Access Compliance Report

Public Rights-of-Way

(Curb Ramps)

Intersection ID: 31415	Main Street: PENDRAGON_DR	Cross Street: ROCKWELL_CHURCH_RD	Location: E
ADA ID: 1341BE121787	Ramp Type: Perp	Initial Pass/Fail: Fail	Overall Compliance: No
Severity Score: 8.75			
Codes/Mitigation Info/Possible Solution		Field Measurements/Component Compliance

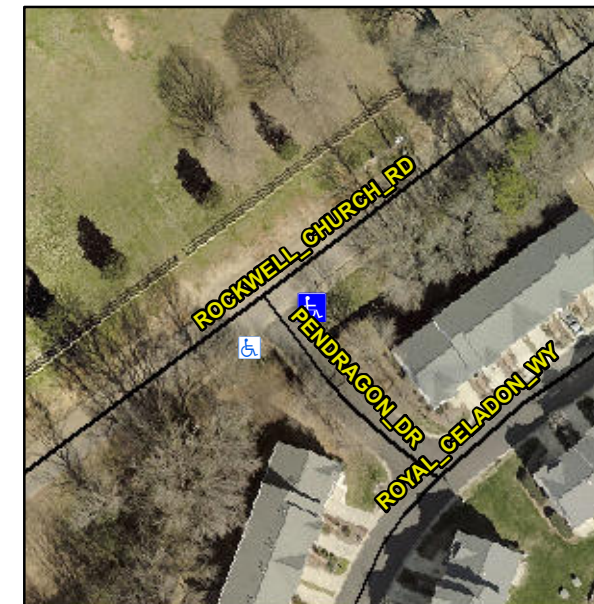
Not Found, R304.5.1

Compliance	Description	Data	Compliance	Description	Data
N/A	Ramp Length (in)	58.0	Yes	Ramp Slope (%)	7.8
No	Ramp Width (in)	44.0	Yes	Ramp XSlope (%)	1.2
N/A	Flare Type LT	N/A	N/A	Flare Type RT	N/A
N/A	Flare Slope LT (%)	N/A	N/A	Flare Slope RT (%)	N/A
N/A	Flare Traversable LT?	N/A	N/A	Flare Traversable RT?	N/A
N/A	Landing Length (in)	N/A	N/A	DWS Provided?	N/A
N/A	Landing Width (in)	N/A	N/A	DWS Contrast?	N/A
N/A	Landing Slope (%)	N/A	N/A	DWS Length (in)	N/A
N/A	Landing X Slope (%)	N/A	N/A	DWS Full Width?	N/A
N/A	Landing Curb? (Y/N)	N/A	N/A	DWS Offset (in)	N/A
N/A	Shared Landing?	N/A			
N/A	Gutter Ponding?	N/A	N/A	Gutter Slope (%)	N/A
N/A	Gutter Lip Ht (in)	N/A	N/A	Gutter X Slope (%)	N/A
N/A	Painted X Walk1?	No	N/A	Painted X Walk2?	N/A
	X Walk 1 Direction	To SW		X Walk 2 Direction	N/A
N/A	X Walk 1 Width (in)	N/A	N/A	X Walk 2 Width (in)	N/A
	X Walk 1 Slope (%)	1.3		X Walk 2 Slope (%)	N/A
	X Walk 1 X Slope (%)	2.0		X Walk 2 X Slope (%)	N/A

Remove & Replace Entire Ramp.
